Overall View – 6" O.D. Core x 58-1/2" Long part

Left Hand View Close-up

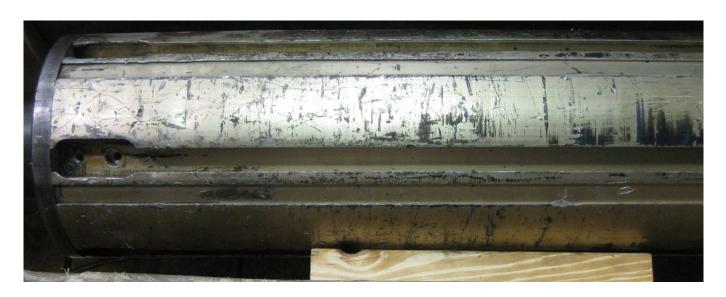
See photo above and below. Note the gap between the steel journal and the aluminum arbor. There are two cap screws missing (of the pattern of (6)). Someone has taken this

apart and not reassembled it properly.
